Project	IEEE 802.16 Broadband Wireless Access Working Group < http://ieee802.org/16 >	
Title	Symmetric UL/DL diversity permutations for OFDMA PHY	
Date Submitted	2004-11-17	
Source(s)	Ran Yaniv, Tal Kaitz, Vladimir Yanover, Naftali Chayat Alvarion Ltd. Yuval Lomnitz Intel Dave Pechner, Todd Chauvin, Doug C. Dahlby ArrayComm Bin-Chul Ihm, Yongseok Jin, Jinyoung Chun, Kyuhyuk Chung LG Electronics, Inc.	ran.yaniv@alvarion.com tal.kaitz@alvarion.com yuval.lomnitz@intel.com dpechner@arraycomm.com chauvin@arraycomm.com dahlby@arraycomm.com bcihm@lge.com jayjay@lge.com jychun03@lge.com kyuhyuk@lge.com
Re:	Call for contributions, IEEE P802.16e/D5 Sponsor Ballot	
Abstract		
Purpose		
Notice	This document has been prepared to assist IEEE 802.16. It is offered as a basis for discussion and is not binding on the contributing individual(s) or organization(s). The material in this document is subject to change in form and content after further study. The contributor(s) reserve(s) the right to add, amend or withdraw material contained herein.

Symmetric UL/DL diversity permutations for OFDMA PHY

Figure 219 – Illustration of OFDMA frame with multiple zones

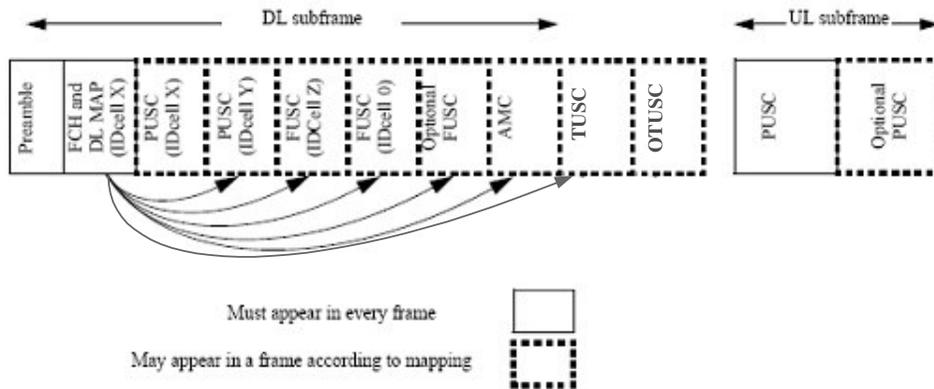
The OFDMA frame may include multiple zones (such as PUSC, FUSC, PUSC with all subchannels, optional FUSC, AMC, ~~and~~ optional FUSC with all subchannels, TUSC, and optional TUSC), the transition between zones is indicated in the DL-Map by the Zone_switch IE (see 8.4.5.3.4). No DL-MAP or UL-MAP allocations can span over multiple zones. Figure 219 depict OFDMA frame with multiple zones.

3. [Replace figure 219 on page 503 with the following figure]

Figure 252e – Mapping of data subcarriers in STC with matrix indicator A.

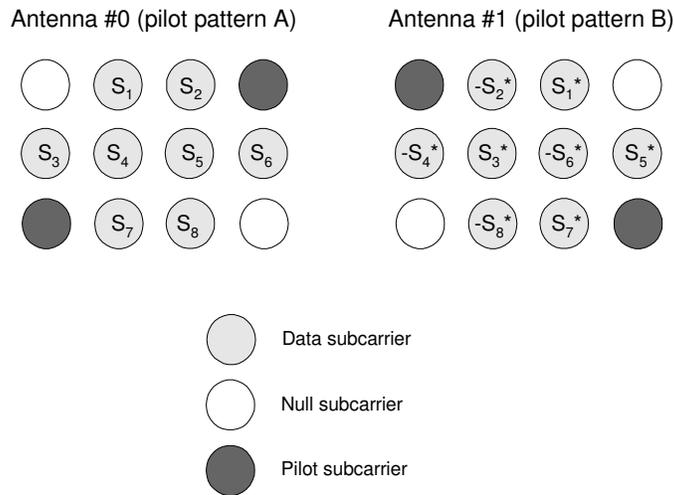
Two STC modes for 2-antenna configuration are defined for the TUSC structure. The first mode, identified by STC matrix indicator ‘A’, provides STC rate of 1 by encoding subcarrier pairs within each tile. In this mode, the tiles shall be allocated to subchannels and the data subcarriers enumerated as defined in 8.4.6.1.2.4. The pilots in each tile shall be split between the two antennas and the data subcarriers shall be encoded in pairs after constellation mapping, as depicted in figure 252e. The data subcarriers transmitted from Antenna #0 follow the original mapping defined in 8.4.6.1.2.4.
